When we reviewed the “Moorebank Intermodal Precinct West – Stage 3 (SSD 10341), Traffic Assessment”, we were somewhat surprised with the expected performances of the intersections on Moorebank Avenue.

Figure 2 Relevant page from M1CL EIS

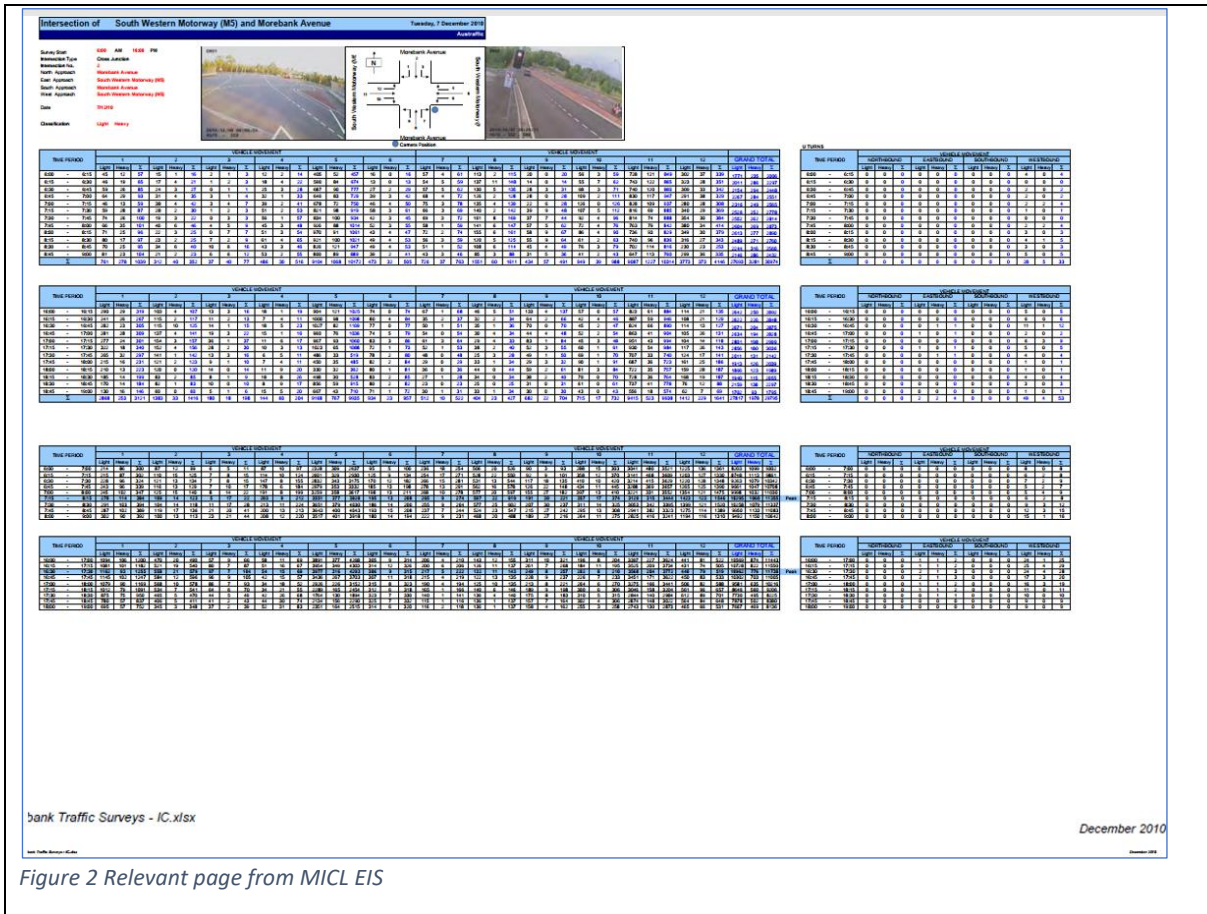
For reference we compared these flows to those that were surveyed on 07/12/2010 for the Moorebank Intermodal Company (MICAL), Environmental Impact Statement (EIS). For convenience, the page is reproduced in Figure 2.

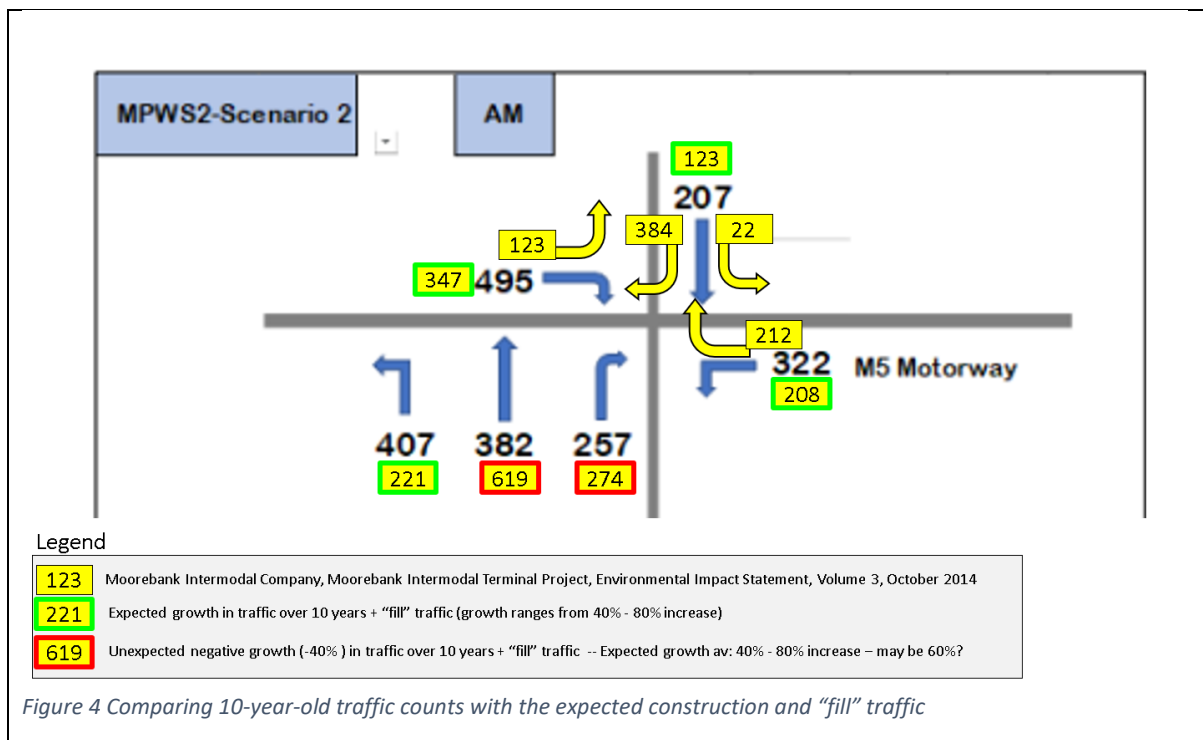
For this submission, Figure 4 compares the ten-year-old surveyed traffic numbers from M1CL, EIS with the Traffic Assessment flows. The Traffic Assessment flows includes the construction and "fill" traffic.

For completeness, all the MICL, EIS flows are shown in yellow boxes, together with the movement arrows. All the yellow boxes show the 10-year-old MICL, EIS numbers.

The yellow boxes with green borders have numbers which are lower numbers than the Traffic Assessment numbers. This is fully expected. There is the 10-year growth in traffic, and the additional construction and "fill" traffic. The growth in traffic varies from 40% to 80%.

The yellow boxes with the red borders have numbers that are higher than the Traffic Assessment numbers.

In the northbound direction, the Traffic Assessment number is 237 vehicles per hour less than the 10-year-old EIS number, and 17 vehicles per hour less for the right-hand-turning movement.

The expected northbound traffic flow represents a **negative growth of 40% over the 10-year old surveyed flows**. Intuitively, the expected number of northbound traffic would consist of two parts: (1) add 40% to bring it to the surveyed flows 10 years ago, then (2) add the expected natural growth as well as the additional construction and "fill" traffic (for the other movements, that ranges from 40% to 80%). Based on this logic, in round figures, the expected northbound traffic should be about double the quoted figure.

From the Traffic Assessment report, it is not immediately obvious why the expected flow is only 40% of the 10-year old surveyed flows.

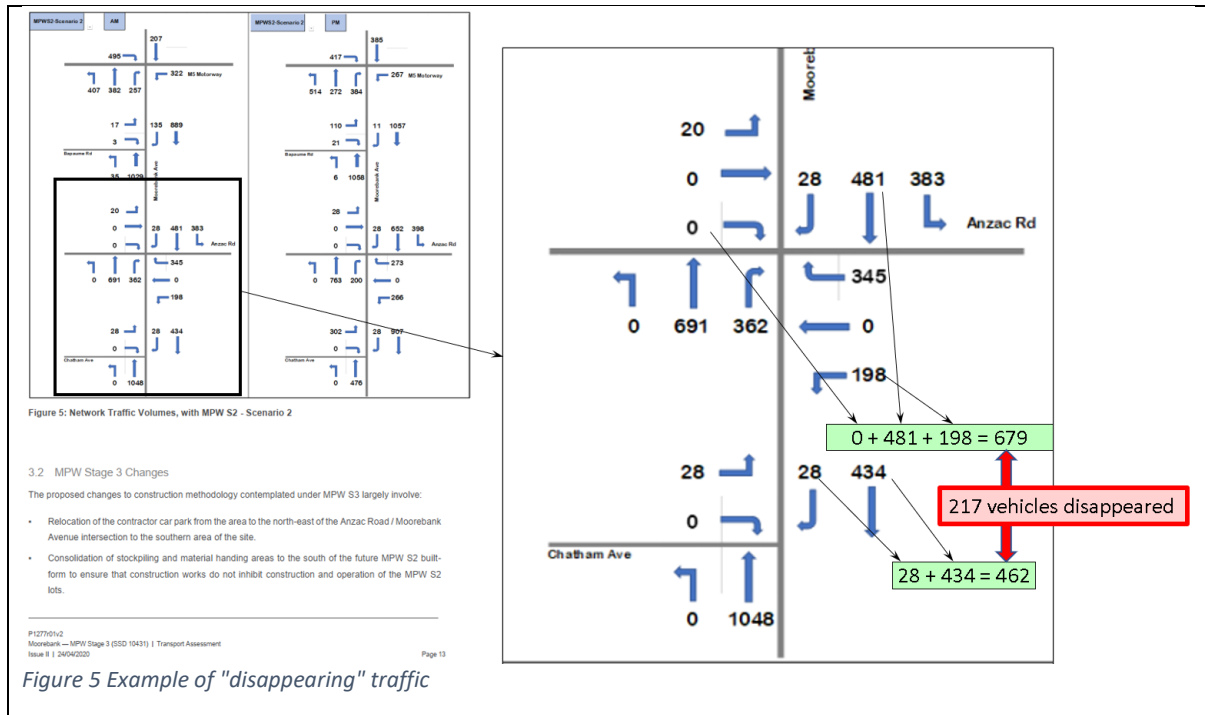
Figure 5 shows the calculation to estimate (1) all traffic travelling southbound, and (2) traffic arriving at the next intersection. In this example, 217 vehicles disappear between two very closely spaced intersections.

No explanation is given on the expected total (growth and additional Moorebank traffic) AM northbound traffic is only 40% of the 10-year old surveyed flow, nor the 217 disappearing vehicles. A simple exercise will show several other instances which do not make sense, or have explanatory notes.
